Accessibility Design Review Report – DA

Project Title: **Proposed Veterinary Hospital**
1121 & 1123 Pittwater Road, Collaroy

Job Number: **20285**

Report Version: **ADR-DA_20285_v1.1**

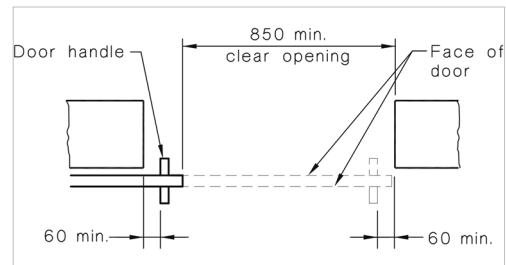
Ensure level transitions or compliant ramps and landings are provided between internal and external areas.

Ensure minimum 30% luminance contrast between doorways and surrounding surfaces is provided.

Verification of 30% luminance contrast between doorways and surrounding surfaces should be provided prior to CC sign off. This can be estimated by obtaining the luminance reflectance value (LRV) of the paint colour or product from the manufacturer, laboratory testing or on site testing prior to completion.

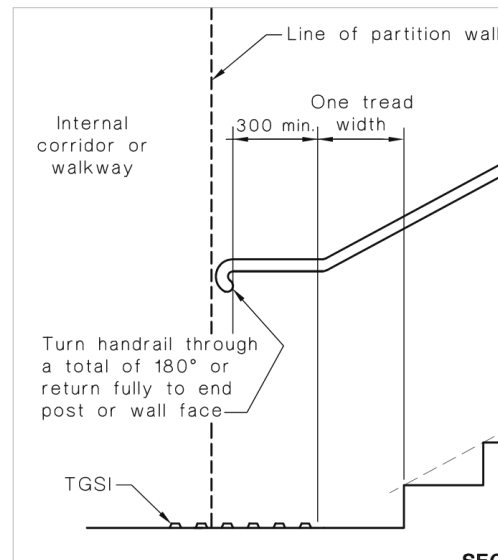
DtS Provision	Comment(s)/Recommendation(s)	Status
<p>In a building required to be accessible every ramp and stairway, except for ramps and stairways in areas exempted by D3.4, must comply with –</p>		
<ul style="list-style-type: none"> • for a ramp, except a fire-isolated ramp, clause 10 of AS 1428.1; and 	<p>Compliance is readily achievable with minor design development and/or specification to AS1428.1-2009 at the Detailed Design Stage.</p>	CoC
<ul style="list-style-type: none"> • for a stairway, except a fire-isolated stairway, clause 11 of AS 1428.1; and 	<p><u>Compliance Departure:</u></p> <p>Several minor technical compliance departures are noted to the stairways of the building.</p>	CoC

Ensure all non-fire isolated stairways are provided with the associated accessible features such as handrails and TGSIs in accordance with AS1428.1 & AS1428.4.

Ensure handrail extensions are setback/protected by a wall or similar in accordance with AS1428.1-2009.

Ensure nosing chamfers/radius is no greater than 5mm x 5mm.

Ensure nosing strips are set back no further than 15mm from the nosing edge (inclusive of the chamfer).

Ensure luminance contrast of nosing strips does not extend down the riser more than 10mm

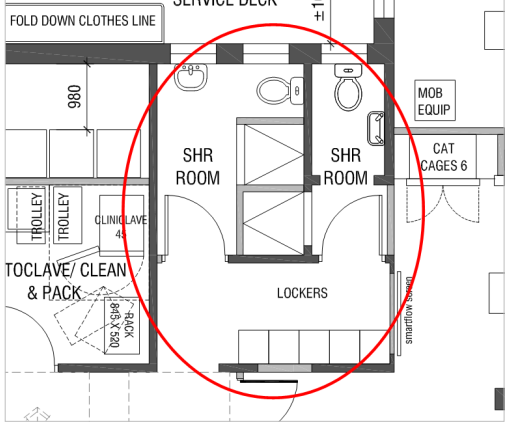
DtS Provision	Comment(s)/Recommendation(s)	Status
<p>In a building required to be accessible:</p> <ul style="list-style-type: none"> • Accessible unisex sanitary compartments must be provided as in accordance with Table F2.4(a), • Accessible unisex showers must be provided in accordance with Table F2.4(b), • At each bank of toilets where there is one or more toilets in addition to an accessible unisex sanitary compartment at that bank of toilets, a sanitary compartment suitable for a person with an ambulant disability in accordance with AS 1428.1 must be provided for use by males and females. • An accessible unisex sanitary compartment must contain a closet pan, washbasin, shelf or bench top and adequate disposal of sanitary towels. • Circulation spaces, fixtures and fittings of all accessible sanitary facilities must comply with AS1428.1. • An accessible unisex sanitary facility must be located so that it can be entered without crossing an area reserved for one sex only; and • Where two or more of each type of accessible unisex sanitary facility are provided, the number of left and right handed mirror image facilities must be provided as evenly as possible. 	<p>Compliance is readily achievable with minor design development and/or specification to AS1428.1-2009 at the Detailed Design Stage.</p> <p><u>Design Detail</u></p> <p>If the first floor area is not deemed acceptable for a D3.4 exemption, a Performance Solution will be required to omit the provision of an accessible unisex sanitary facility and male/female ambulant sanitary compartments.</p> 	CoC
